BANG NOISE HEARD AND/OR BUMP FELT FROM FRONT OF VEHICLE DURING A QUICK 1-2 AND/OR 2-3 SHIFT—UNDER MODERATE TO AGGRESSIVE ACCELERATION

TSB 13-6-10

FORD:
2013 Focus

Figure 1 - Article 13-6-10

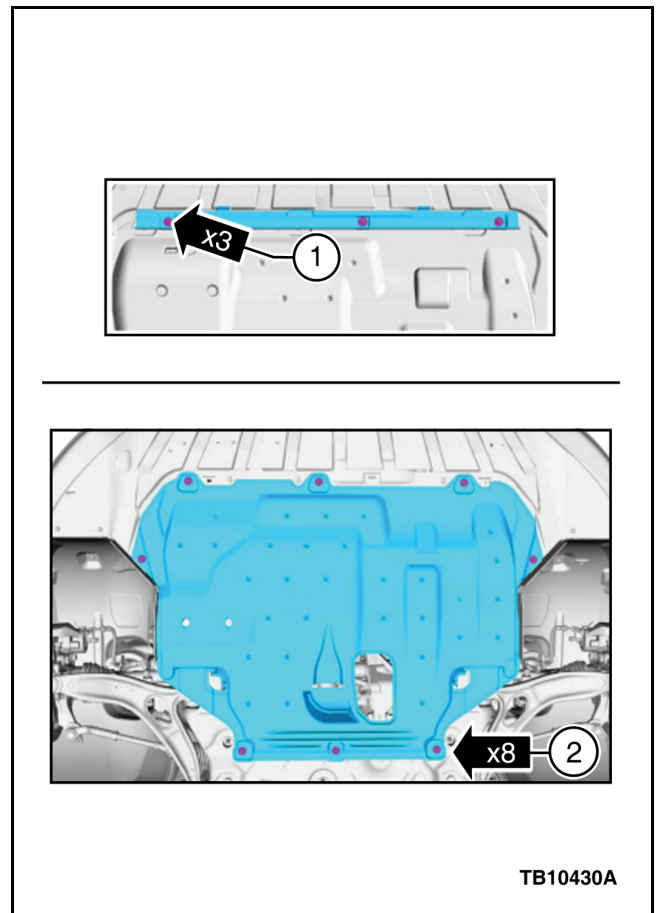
1. Raise the vehicle on a hoist. Refer to Workshop Manual (WSM), Section 100-02.
2. Remove the lower air deflector by removing the three (3) fasteners. (Figure 1)
3. Remove the engine compartment splash shield by removing the eight (8) fasteners. (Figure 1)
4. Lower the vehicle.
5. Remove battery and battery tray. Refer to WSM, Section 414-01.
6. Position hydraulic floor jack with a wood block under transmission and raise only enough to support weight of transmission.
 - a. Do not attempt to lift the transmission or damage will occur.

Figure 2 - Article 13-6-10

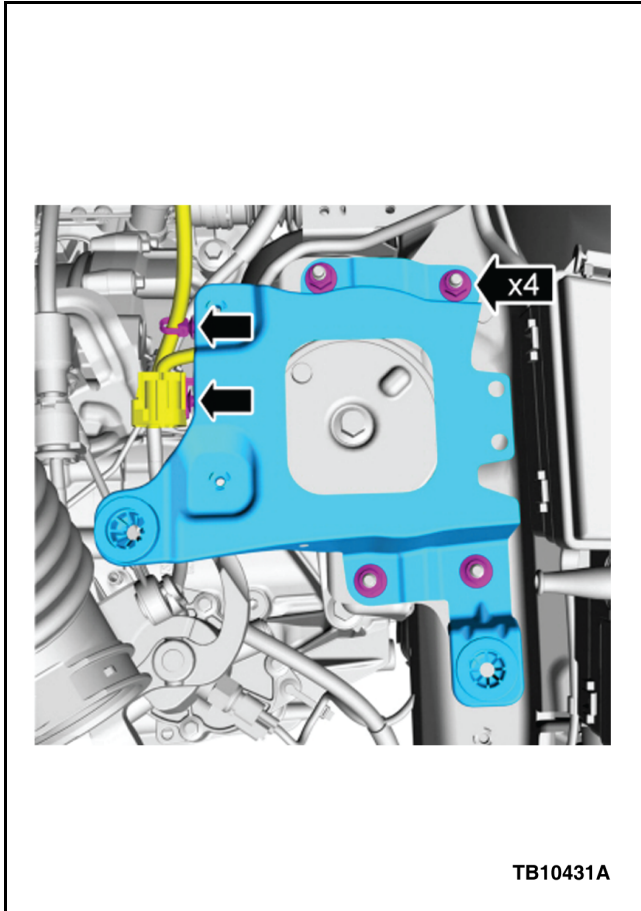
7. Remove battery tray reinforcement by removing the four (4) fasteners. (Figure 2)

Figure 3 - Article 13-6-10

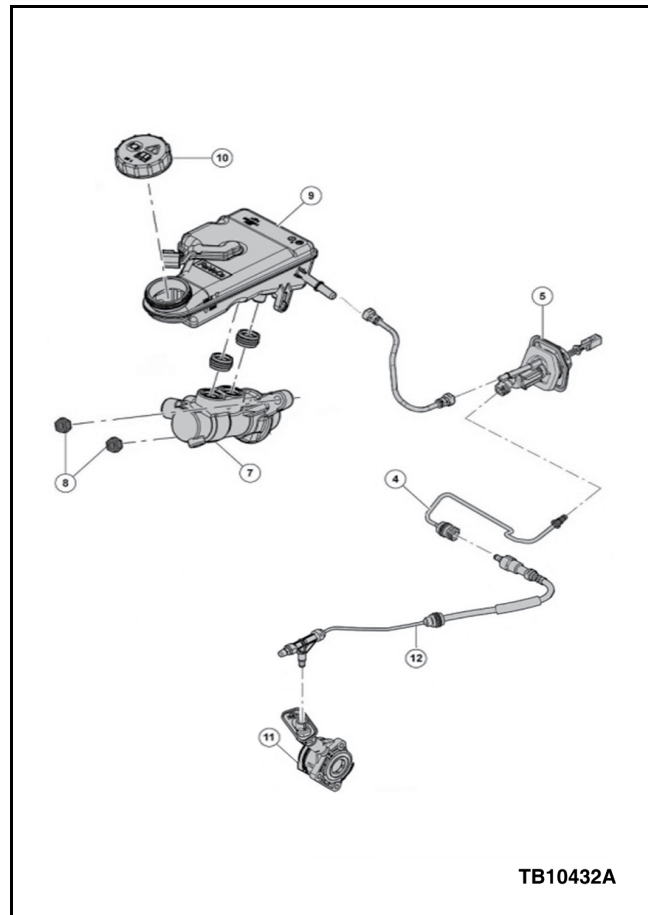
8. Remove and discard the center fastener securing the transmission support insulator and remove the insulator.
9. Install revised service transmission support insulator and torque new center fastener to 148 N•m (109 lb-ft).
10. Replace the clutch slave cylinder hydraulic tube with revised service part. (Figure 3 - Item 12)
11. Bleed the clutch system. Refer to WSM, Section 308-02, general procedures, 6 speed manual transmissions.
12. Remove floor jack.
13. Install battery tray reinforcement with the four (4) fasteners and torque to 48 N•m (35 lb-ft). (Figure 2)
14. Install battery and battery tray, refer to WSM, Section 414-01.
15. Replace engine mount with revised service part. Refer to WSM, Section 303-01B
